FORT CALHOUN STATION, UNIT NO. 1

AMENDMENT TO FACILITY OPERATING LICENSE

Amendment No. 100  
License No. DPR-40

ATTACHMENT TO LICENSE AMENDMENT NO. 100

FIGURE  
2-1A

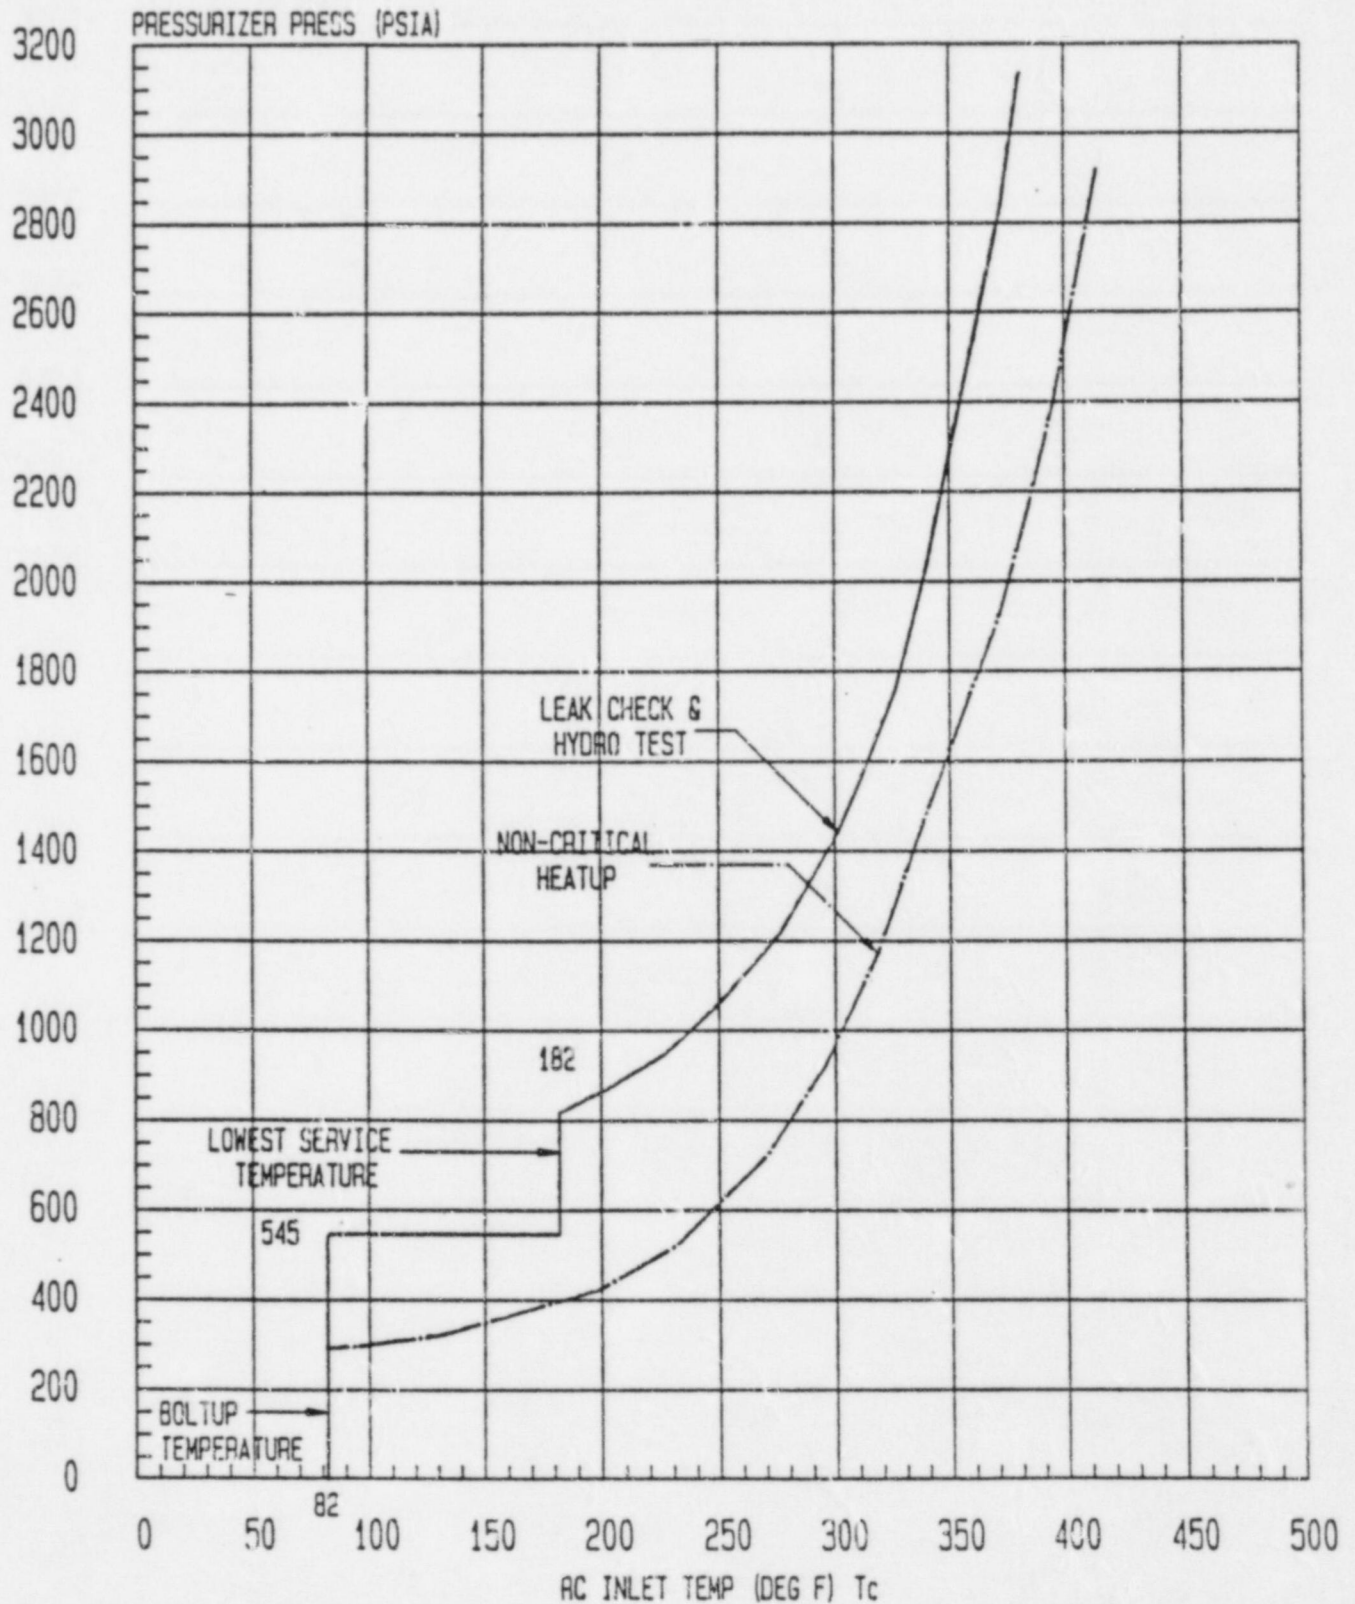
- (c) The limit lines in Figures 2-1A and 2-1B shall be moved parallel to the temperature axis (horizontal) in the direction of increasing temperature a distance equivalent to the transition temperature shift during the period since the curves were last constructed. The boltup temperature limit line shall remain at 82°F as it is set by the NDTT of the reactor vessel flange and not subject to fast neutron flux. The lowest service temperature shall remain at 182°F because components related to this temperature are also not subject to fast neutron flux.

The limit lines in Figures 2-1A and 2-1B are based on the following:

- A. Heatup and Cooldown Curves - From Section III of the ASME Code, Appendix G-2215.

The above equation is applied to the reactor vessel beltline. For plant heatup the thermal stress is opposite in sign from the pressure stress and consideration of a heatup rate would allow for a higher pressure. For heatup it is therefore conservative to consider an isothermal heatup or  $K_{IT} = 0$ .

FIGURE  
2-1B

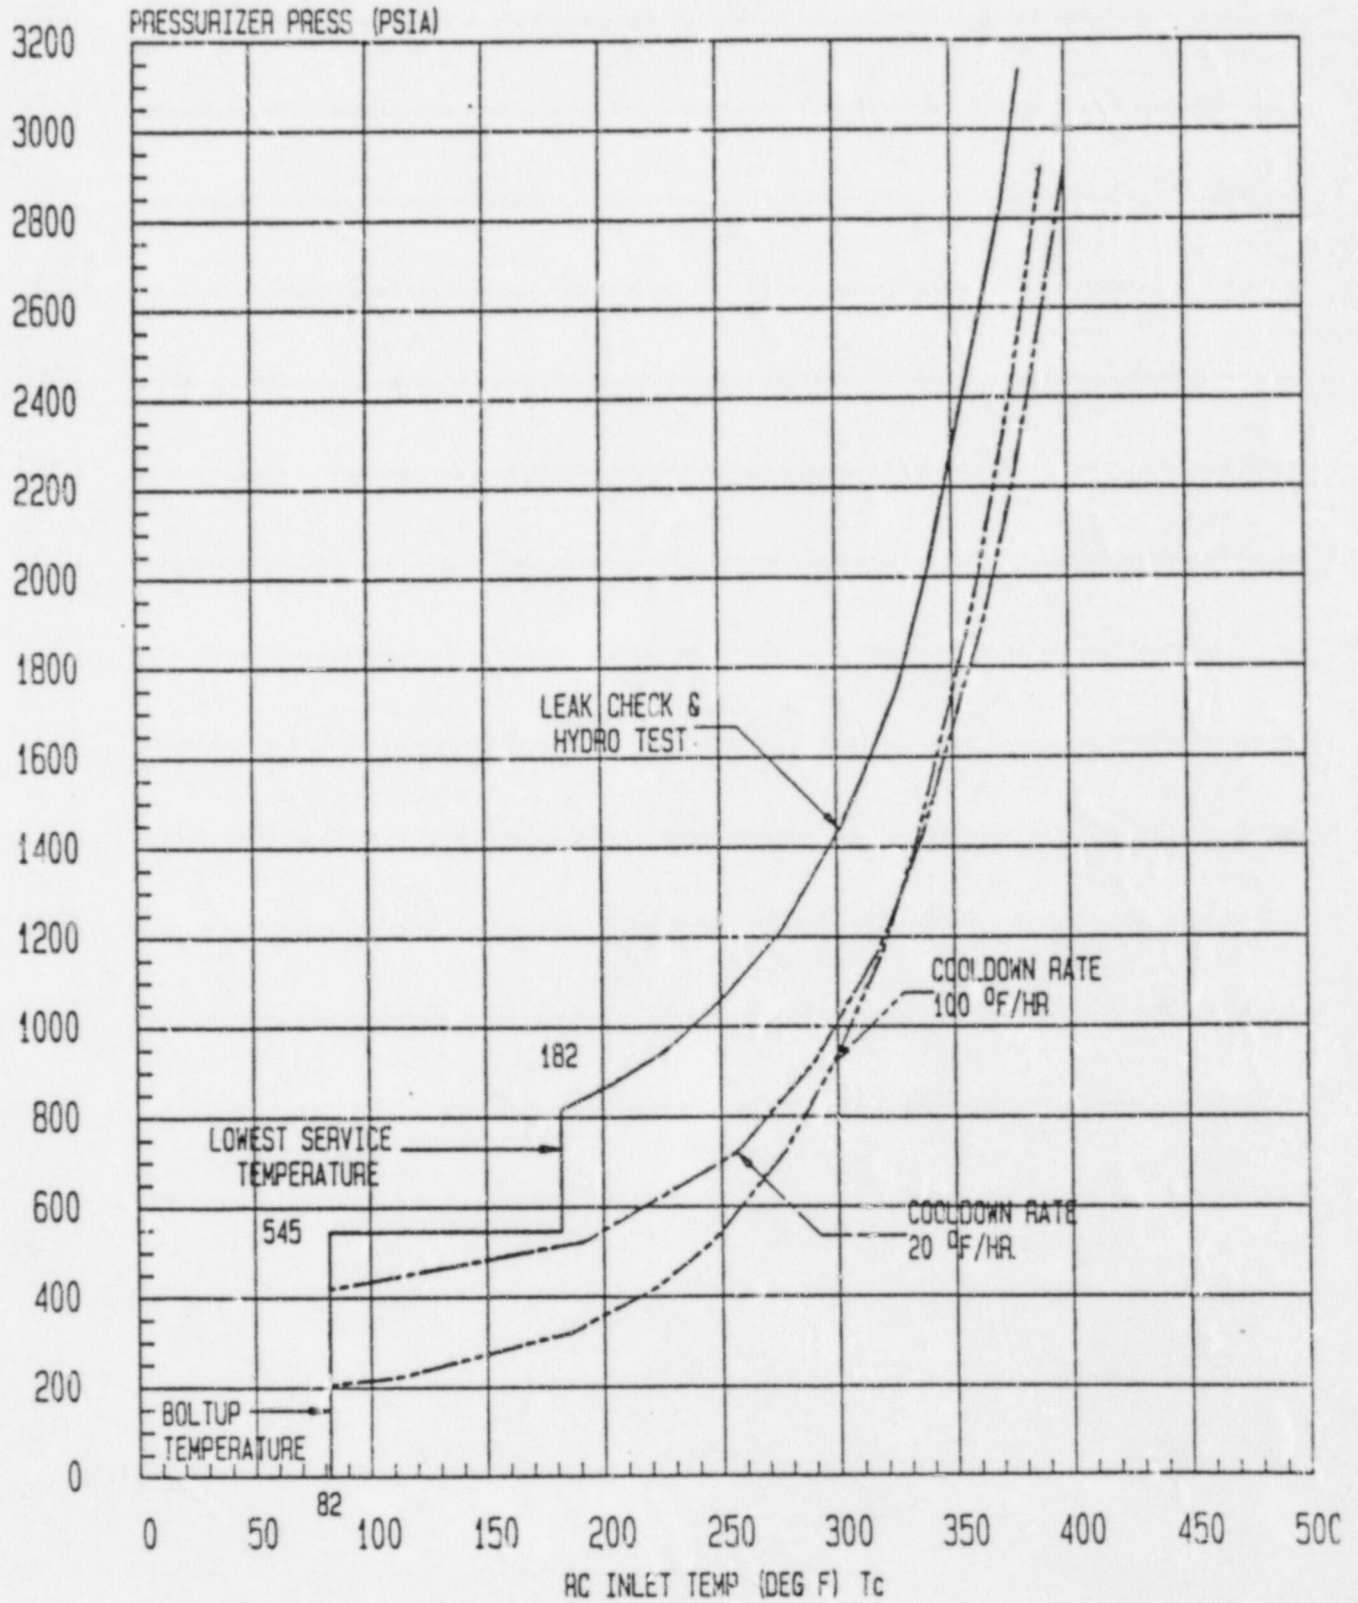
Inadvertent actuation of three (3) HPSI pumps and three (3) charging pumps, coincident with the opening of one of the two PORV's, would result in a peak primary system pressure of 1190 psia. 1190 psia corresponds with a minimum permissible temperature of 320°F on Figure 2-1B. Thus, at least one HPSI pump is disabled at 320°F.

Inadvertent actuation of two (2) HPSI pumps and three (3) charging pumps, coincident with the opening of one of the two PORV's, would result in a peak primary system pressure of 1040 psia. 1040 psia corresponds with a minimum permissible temperature of 312°F on Figure 2-1B. Thus, at least two HPSI pumps will be disabled at 312°F.

Inadvertent actuation of one (1) HPSI and three (3) charging pumps, coincident with opening of one of the two PORV's, would result in a peak primary system pressure of 685 psia. 685 psia corresponds with a minimum allowable temperature of 271°F on Figure 2-1B. Thus, all three HPSI pumps will be disabled at 271°F.

Inadvertent actuation of three (3) charging pumps, coincident with the opening of one of the two PORV's, would result in a peak primary system pressure of 160 psia. 160 psia would correspond with a minimum allowable temperature that is less than the 82°F boltup temperature limit on Figure 2-1B. Therefore, operation of the charging pumps need not be restricted.

Whenever the reactor coolant system cold leg temperature is below 320°F, at least one (1) HPSI pump shall be disabled.

Whenever the reactor coolant system cold leg temperature is below 312°F, at least two (2) HPSI pumps shall be disabled.

Whenever the reactor coolant system cold leg temperature is below 271°F, all three (3) HPSI pumps shall be disabled.

FIGURE  
2-3

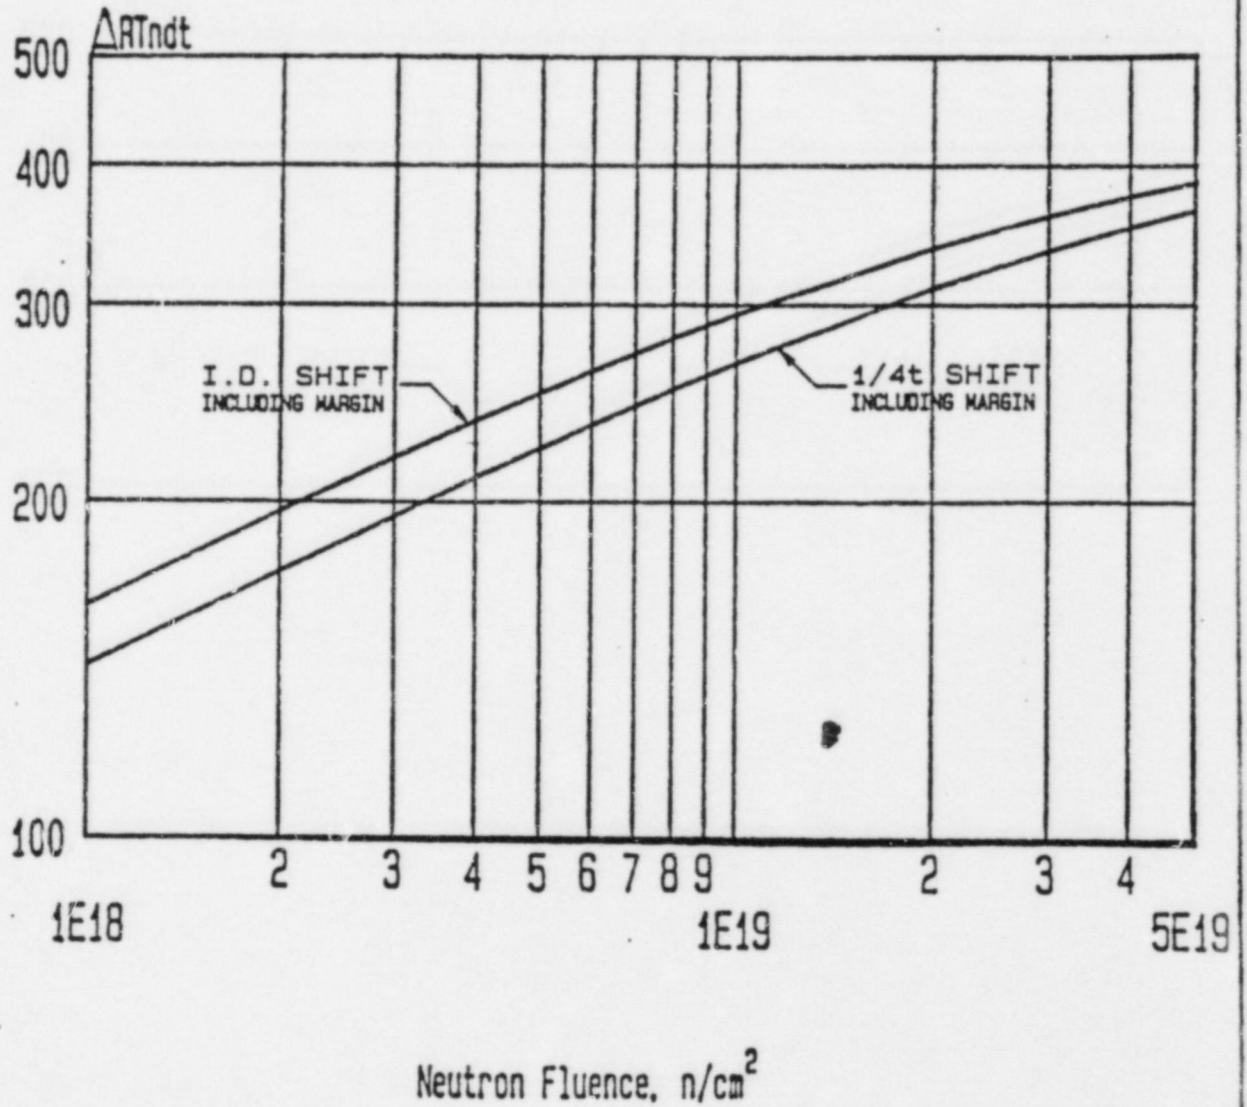
- (a) The curve in Figure 2-3 shall be used to predict the increase in transition temperature based on integrated fast neutron flux. If measurements on the irradiation specimens indicate a deviation from this curve, a new curve shall be constructed.

- (b) The limit line on the figures shall be updated for a new integrated power period as follows: the total integrated reactor thermal power from startup to the end of the new period shall be converted to an equivalent integrated fast neutron exposure ( $E > 1$  MeV). For this plant, based upon surveillance materials tests, weld chemical composition data, and the effect of a reduced vessel fluence rate provided by core load designs beginning with fuel Cycle 8, the predicted surface fluence at the initial reactor vessel beltline weld material for 40 years at 1500 MWt and an 80% load factor is  $2.9 \times 10^{19}$  n/cm<sup>2</sup>. The flux reduction applied to the fluence calculations was based on a Cycle 1-9 average azimuthal flux distribution plot generated using DOT 4.3. The predicted transition temperature shift to the end of the new period shall then be obtained from Figure 2-3.

1500 Mwt and 80% load factor. The predicted shift at this location at the 1/4t depth from the inner surface is 332°F, including margin, and was calculated using the shift prediction equation of the proposed Regulatory Guide 1.99, Revision 2. The actual shift in  $T_{NDT}$  will be re-established periodically during the plant operation by testing of reactor vessel material samples which are irradiated cumulatively by securing them near the inside wall of the reactor vessel as described in Section 4.5.3 and Figure 4.5-1 of the USAR. To compensate for any increase in the  $T_{NDT}$  caused by irradiation, limits on the pressure-temperature relationship are periodically changed to stay within the stress limits during heatup and cooldown. Analysis of the second removed irradiated reactor vessel surveillance specimen<sup>(8)</sup>, combined with weld chemical composition data and reduced core loading designs initiated in Cycle 8, indicates that the fluence at the end of 15.0 Effective Full Power Years (EFPY) at 1500 Mwt will be  $1.4 \times 10^{19}$  n/cm<sup>2</sup> on the inside surface of the reactor vessel. This results in a total shift of the  $RT_{NDT}$  of 285°F, including margin, for the area of greatest sensitivity (weld metal) at the 1/4t location as determined from Figure 2-3. Operation through fuel Cycle 16 will result in less than 15.0 EFPY.
